International Code Council

ICC 500-2023 edition
Comments on the 1st draft
based on input received
on 2020 edition of the
ICC 500 Standard
9-7-2023

Matrix for ICC 500 Comments

2020 ICC 500-Standard Revision Proposals

Figure 306.4.1.1
Door clearance

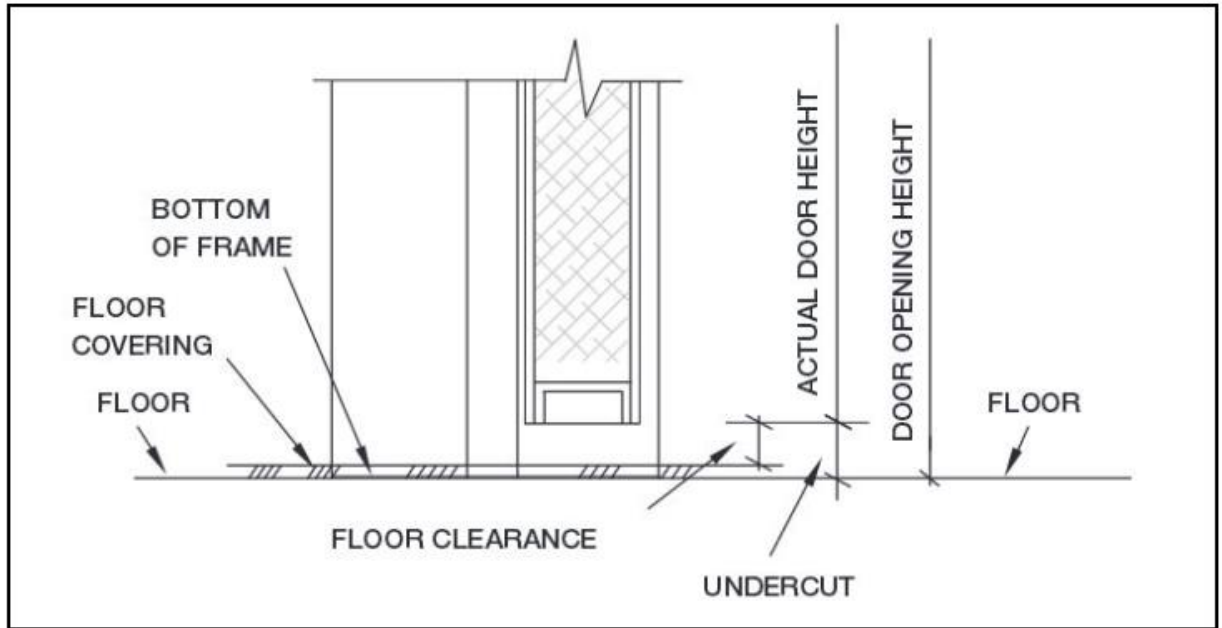
From NFPA 80 – need new figure similar to this, but add threshold, change verbiage to match text.

306.4.1.1 Door undercut clearance. Floor clearance for door Door assemblies for use in the storm shelter envelope with a threshold at the level of exit discharge shall be limited to a 3/4-inch (19.1 mm) maximum, undercut measured from the top of the threshold or finished floor. (See example in Figure 306.4.1.1).

Figure 306.4.1.1
Door clearance

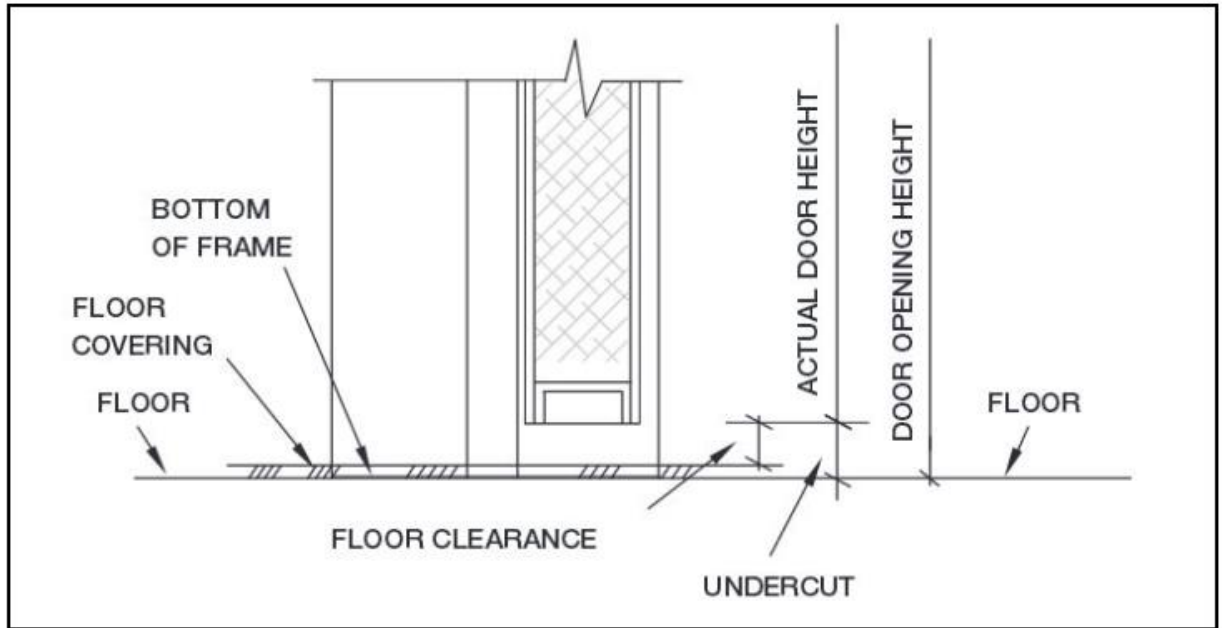
From NFPA 80 – need new figure similar to this, but add threshold, change verbiage to match text.

306.4.1.1 Door undercut clearance. Floor clearance for door Door assemblies for use in the storm shelter envelope with a threshold at the level of exit discharge shall be limited to a 3/4-inch (19.1 mm) maximum, undercut measured from the top of the threshold or finished floor. (See example in Figure 306.4.1.1).

Figure 306.4.1.1
Door ~~clearance~~ Undercut

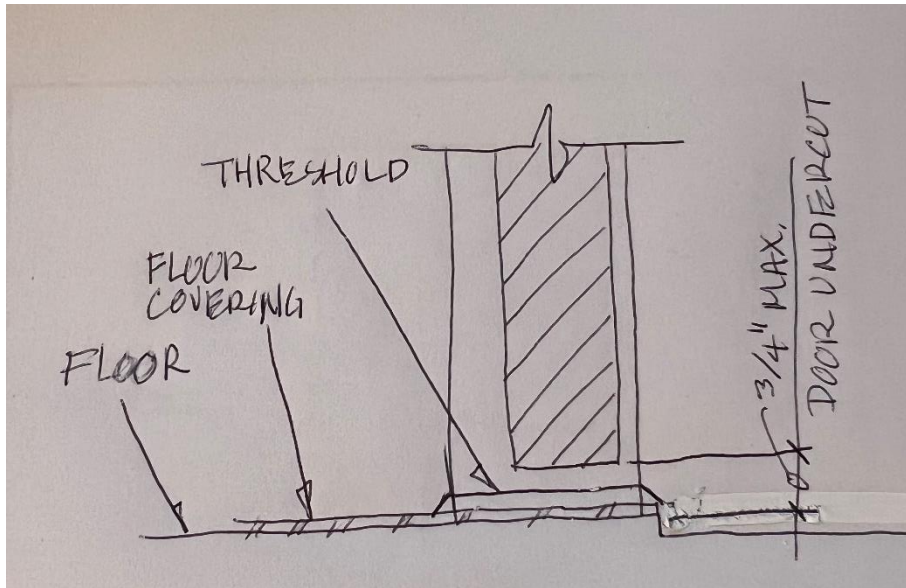
9-22-23: Return to Work Group 3. See minutes for draft worked on during the meeting.

306.4.1.4 Door undercut. Door assemblies in the storm shelter envelope shall be limited to a 3/4-inch (19.1 mm) maximum undercut. (See example in Figure 306.4.1.4).

Figure 306.4.1.1
Door ~~clearance~~-undercut

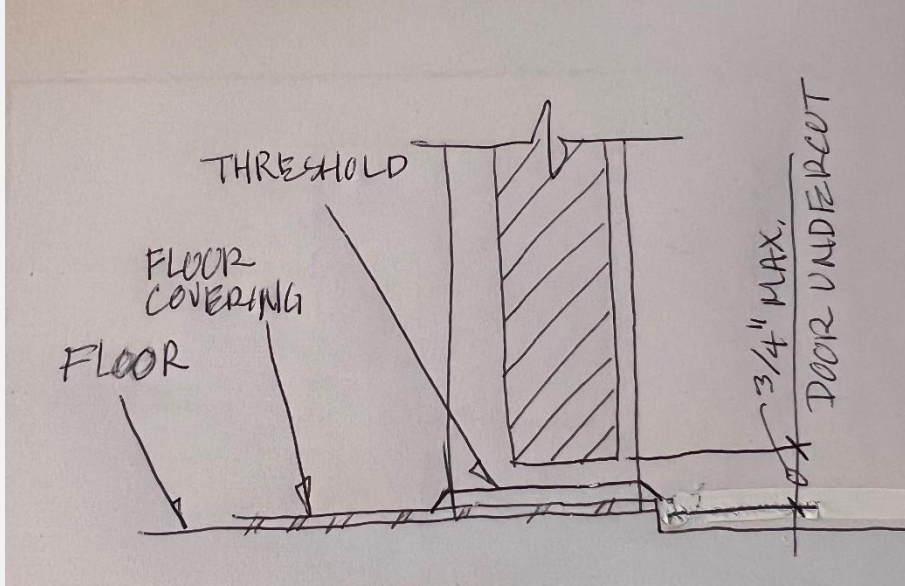
Committee Reason: The modification uses consistent language for the gap between double doors. The undercut on storm shelter doors is measured as indicated on the proposed graphic – to the unfinished floor, not the floor covering or threshold. The undercut is the dimension the bottom latches and latch bolts are typically based upon for testing. The floor covering is not a structural element so it should not be considered when setting the base requirement.

306.4.1.4 Door undercut clearance. ~~Floor clearance for door Door~~ assemblies in the storm shelter envelope shall be **limited to a** 3/4-inch (19.1 mm) maximum **undercut measured from the top of the threshold or finished floor.** (See example in Figure 306.4.1.4).

Figure 803.9.6(3) LOUVER IMPACT TOLERANCE

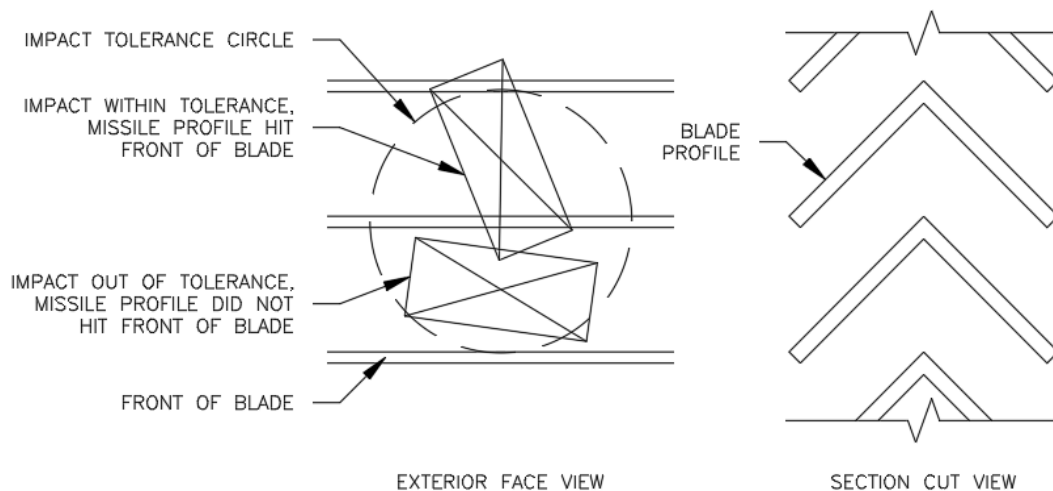
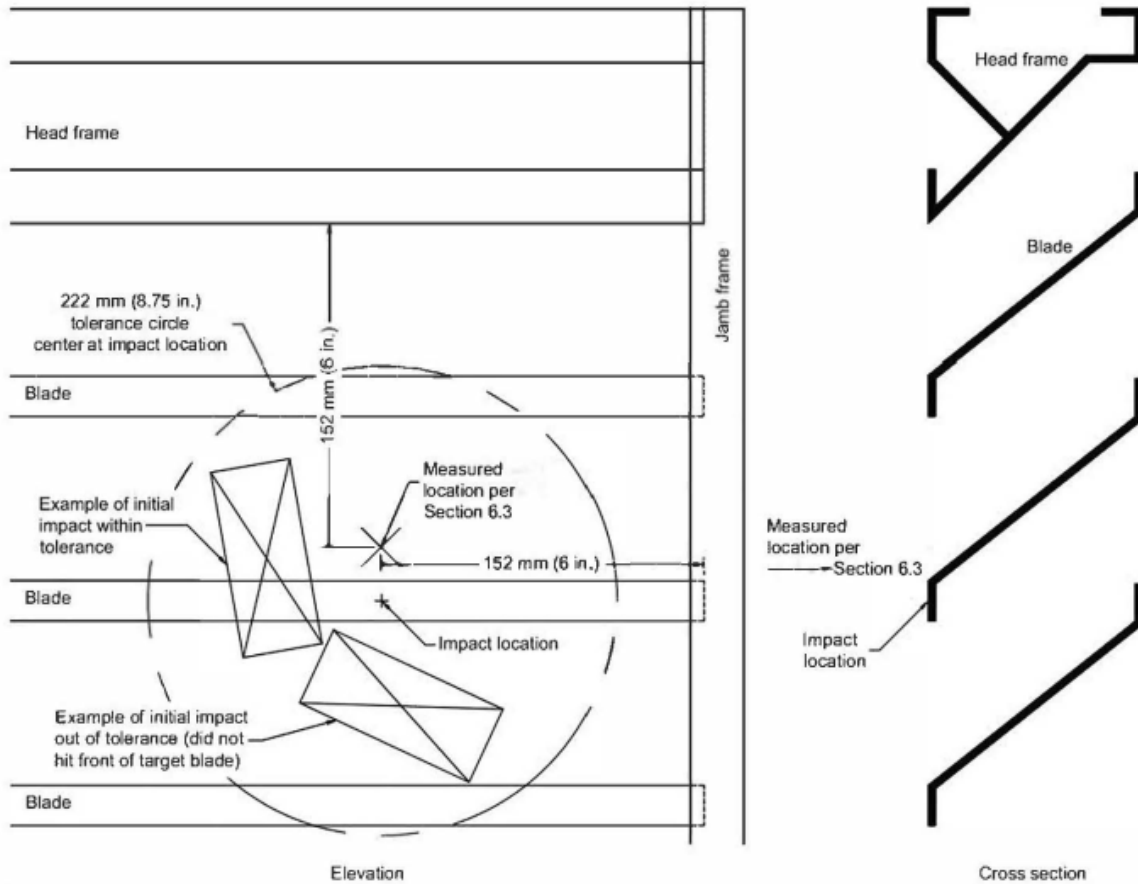
Reason: First sentence: Due to the draft's new section 306.4.1.5 "Louvers" and its test requirements for louvers to be tested per the IPS section, the IPS impact section needs to add a vulnerable impact location of a louver, which is at mid-span of the louver blade's free span. This is similar to impacting at the center of a glazed opening (required in section 803.9.5) and impacting centered between wall supports (required in section 803.9.1).

Was added to reincorporate a small portion of a disapproved proposal of an entire new section regarding louver specific test requirements (IS-STM 08-08-23). Now being proposed is only a single sentence instead of an entire new section. The sentence was modified from the original IS-STM 08-08-23 proposal. The sentence ensures the missile makes initial impact on the front of a louver blade, which prevents an impact failure due to the test missile sneaking between two blades and making first impact at a location mid-depth within the louver. Similar language is in AMCA Standard 540, "Test Method for Louvers Impacted by Wind Borne Debris", which has been accepted by Miami-Dade County, the Florida Building Code, and the IBC. A new figure is proposed to assist in the understanding, which is modified from a figure in AMCA 540 (shown below).

Louvers shall be additionally impacted at mid-span of the blade's longest free-span of each test specimen and the impact shall be permitted be non-centered when measured perpendicular to the blade span. Where an impact location is on the blade of a louver, the leading face of the test missile shall impact the exterior face or edge of at least one blade prior to proceeding deeper into the louver (see Figure 803.9.6(3) for an example).

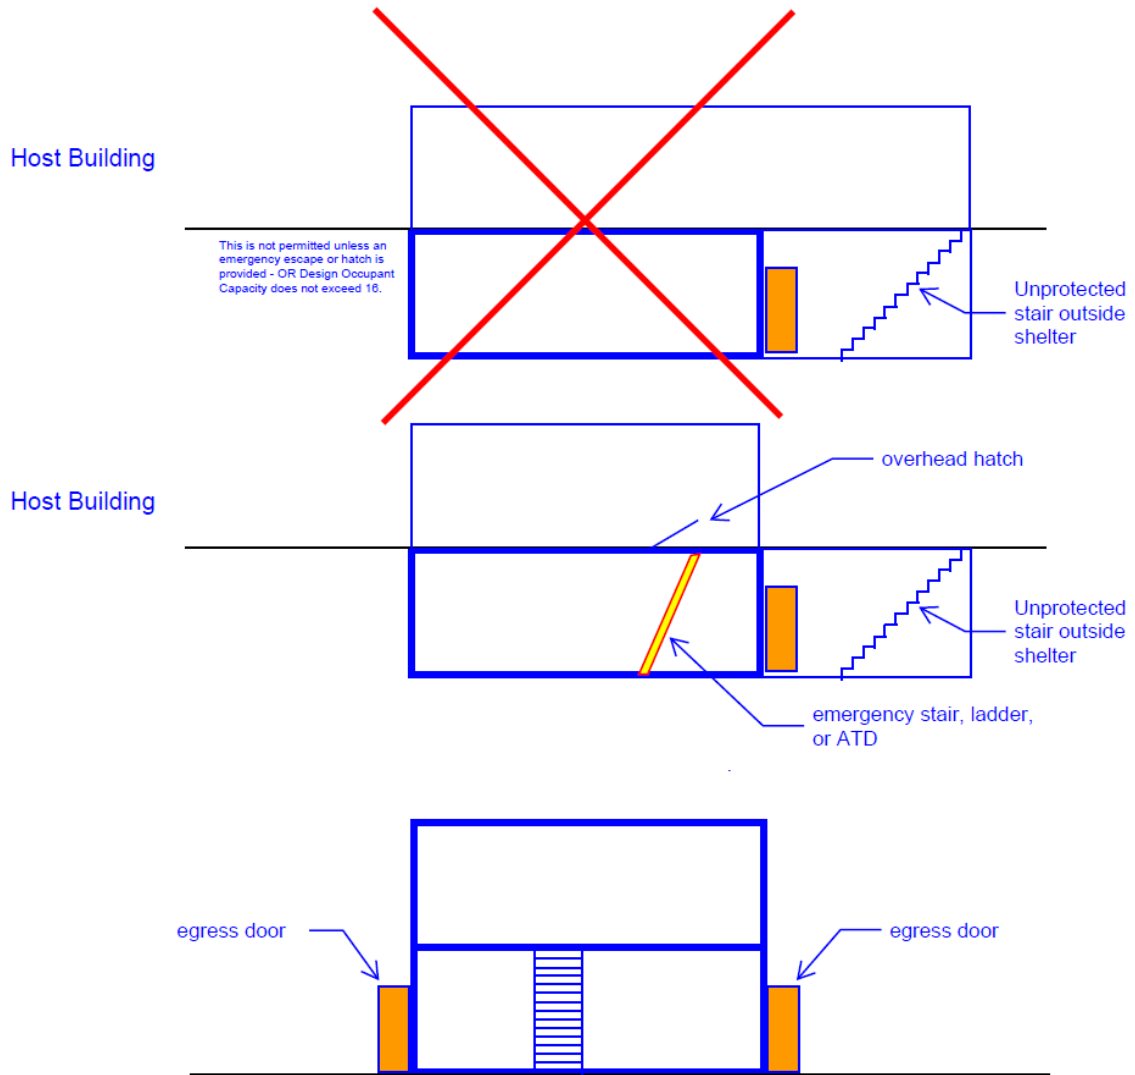
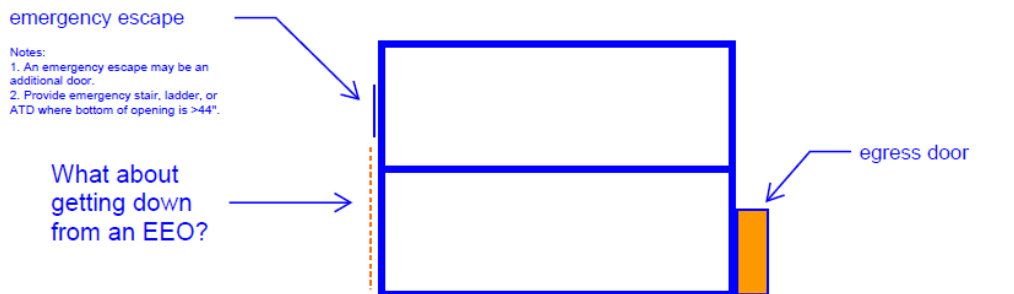
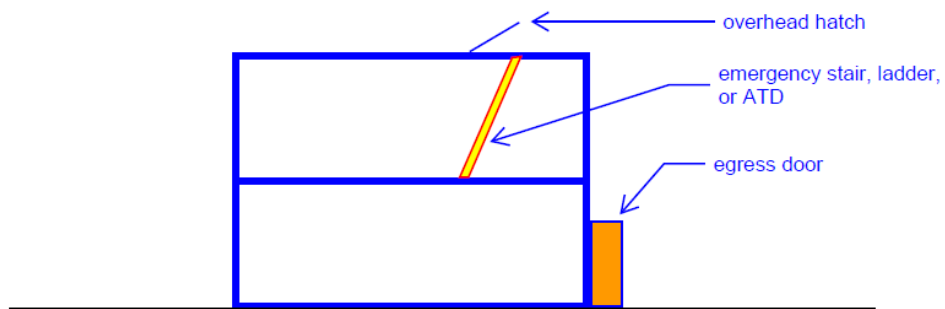
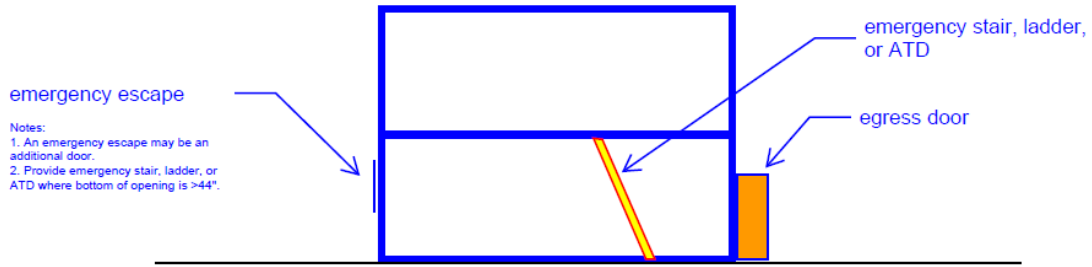
Committee Reason: The purpose of this requirement is to minimize the chance of entrapment due to falling debris or access to the exit stairways within the building being unavailable. This encompasses basements and 2nd story levels of shelters.

The following diagrams were shown during the meeting to explain the change.

FIGURE 803.9.4.3 SECTIONAL DOOR ASSEMBLIES

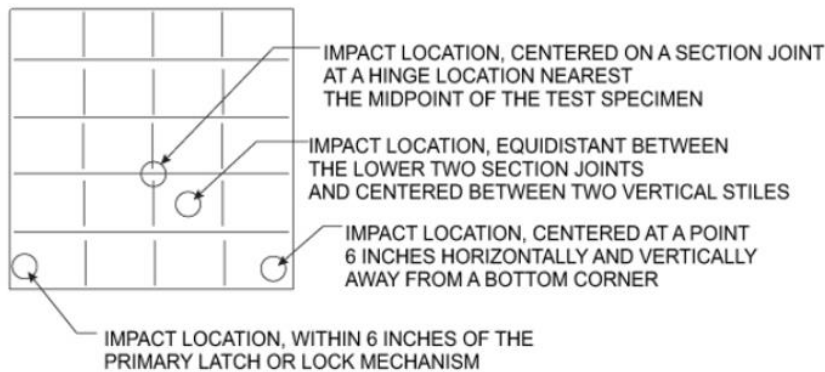
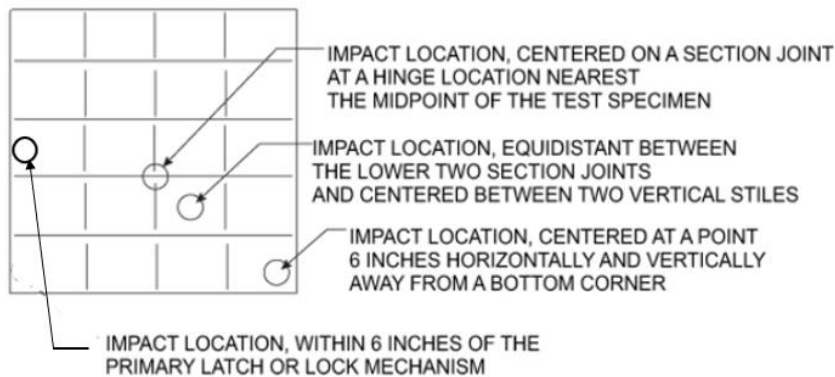
Reason: Cleanup and clarity of text to align with Figure. There should not be variation in the text between the section language and the figure.

803.9.4.3 Sectional door assemblies. For sectional door assemblies, the door shall be impacted centered on a section joint at a hinge location nearest the midpoint of the test specimen, equidistant between the lower two section joints and centered between two vertical stiles, centered at a point 6 inches horizontally and vertically away from a at one bottom corner, and within 6 inches (152 mm) of the primary latch or lock mechanism as shown. See example in Figure 803.9.4.3.

FIGURE 803.9.5(1)
WINDOW ASSEMBLIES AND OTHER GLAZED OPENINGS

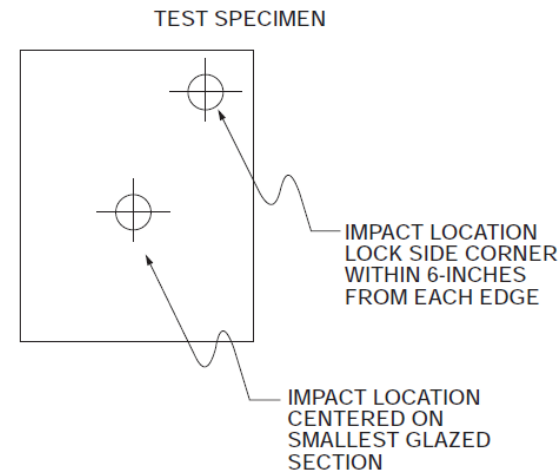
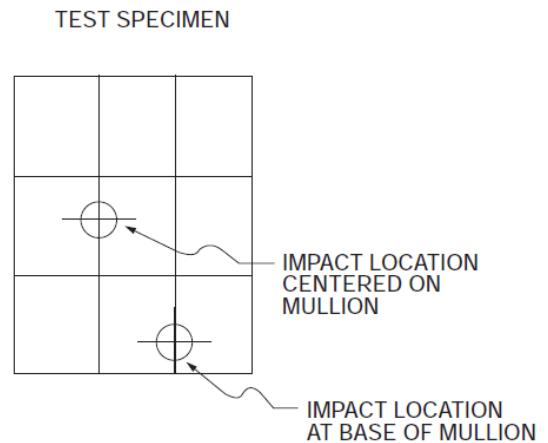
Modify figure 803.9.5(1) to include 'one interface corner' in note

803.9.5 Window assemblies and other glazed openings. All window assemblies and other glazed openings shall be impacted in the center of the smallest glazed section, and at ~~the lock side corner, or one interface corner, a corner~~ within 6 inches from each edge. Where a lock/latch is provided on the test specimen, the corner impact shall occur nearest the lock/latch. as applicable as detailed See example in Figure 803.9.5(1). Where interior mullions or other glazed section joints are present, the assembly shall be impacted centered on the mullion and at base of mullion as shown in Figure 803.9.5(2). Interface hinge joints and primary latches, where present, shall be impacted as shown in Figure 803.9.4.1(2) on an additional specimen.
